Florida Keys Aqueduct Authority

RE: Turkey Point Units 6 and 7
Florida Power & Light (FPL) Nuclear Power Plant
Environmental Impact Statement (EIS)

**MIAMI-DADE COUNTY COMPLETENESS COMMENTS FOR
FPL SITE CERTIFICATION APPLICATION - TURKEY POINT UNITS 6 and 7**

DRAWING TITLE
**Surface Water / Salt Intrusion
 Source Map**

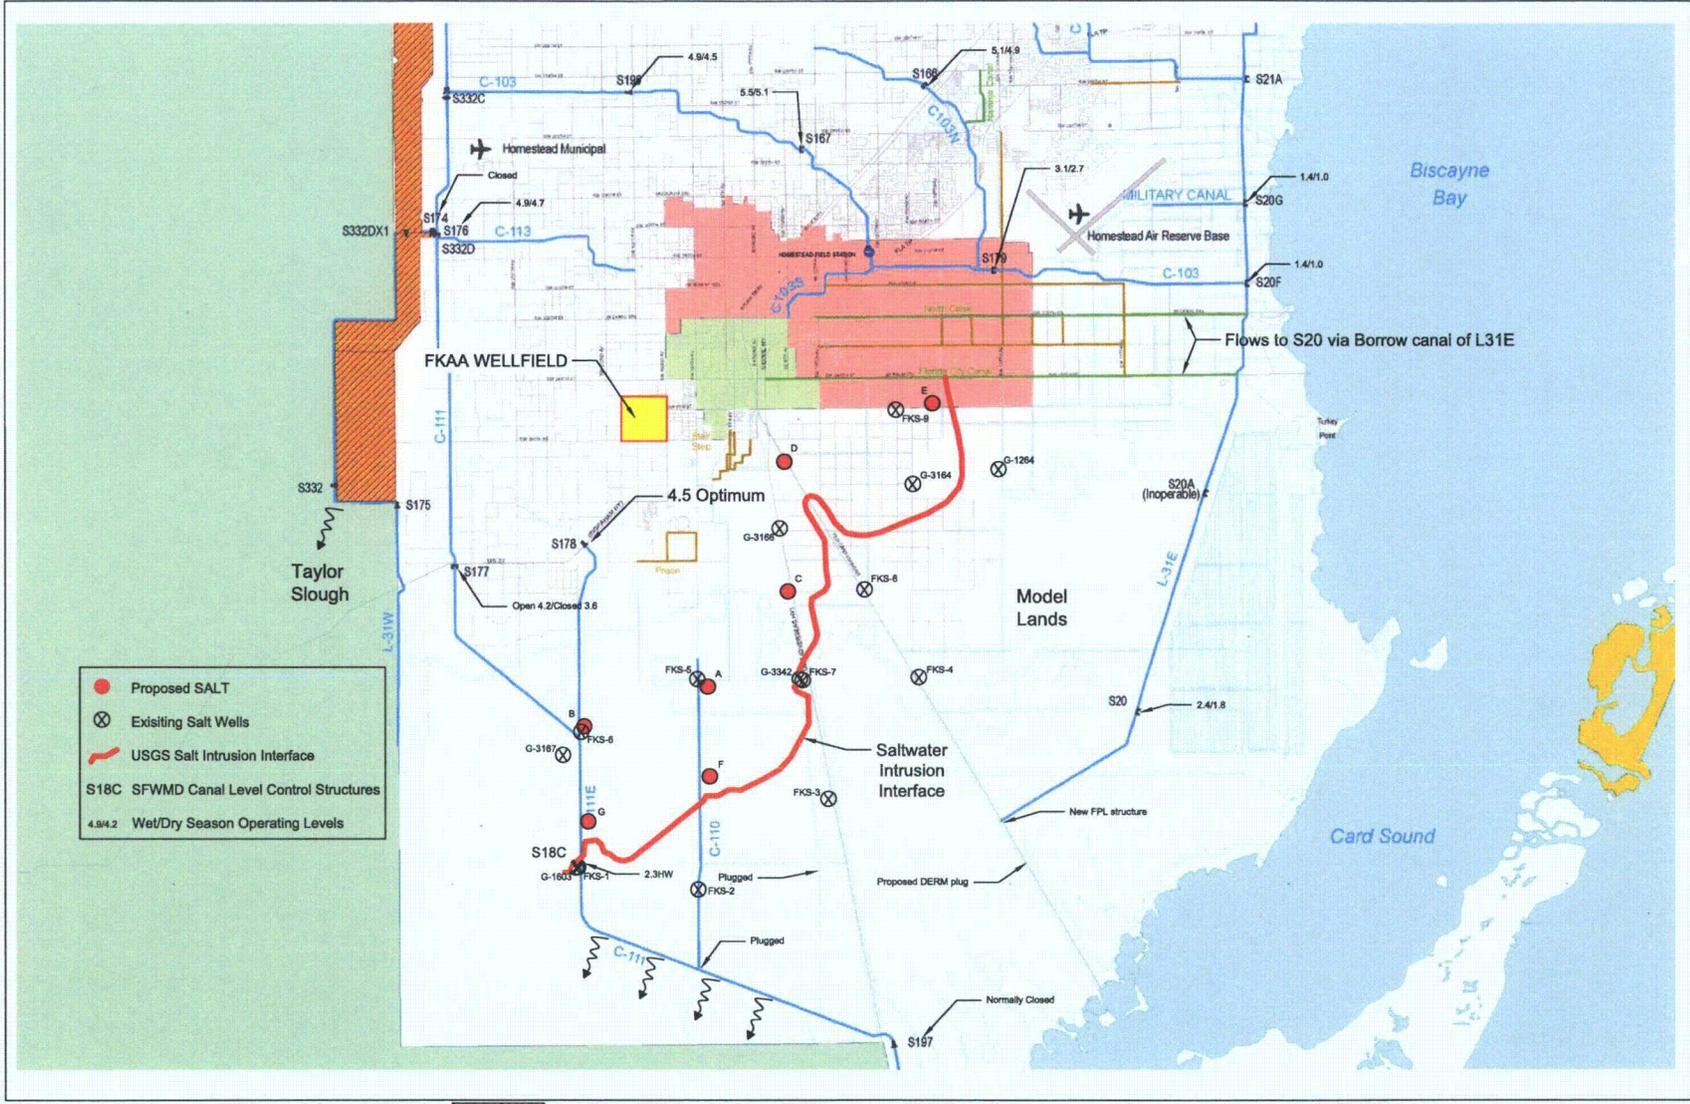
As an agency with responsibility to provide our customers with a clean and sustainable fresh water supply for Monroe County which is surrounded by seawater, we have concerns for any potential impacts to our water supply. As the proposed project is significant in size and nature, conducting a comprehensive EIS to address key concerns and impacts to the natural resources is a necessary part of the evaluation process. It is our understanding that FPL's existing cooling water canal system, located west and south of the power plant contains high salinity concentrations. This high salinity is derived from evaporation of natural sea water discharged within these cooling water canals. As the highly concentrated seawater enters the groundwater along the bottom and the sides of the canals, the receiving groundwater becomes more saline. Without adequately operating system controls, this hydrogeological process can continue with a resultant salt load into a fresher groundwater aquifer. The higher saline groundwater with a higher specific gravity can increase the rate and amount of salt water intrusion from east to west in the Biscayne Aquifer and toward the FKAA wellfield.

1. The FKAA requests that additional ground water modeling and monitoring be presented at the current salt/fresh water interface of the Biscayne Aquifer. As you see in the attached ground water monitoring plan, a trend has been shown and interface presented in collaboration with the USGS and Miami-Dade County to demonstrate the current interface location and its movement. For the EIS, modeling of potential changes to the interface position of this salt/fresh interface resulting from the proposed impacts from the construction and operation of the facility is requested.
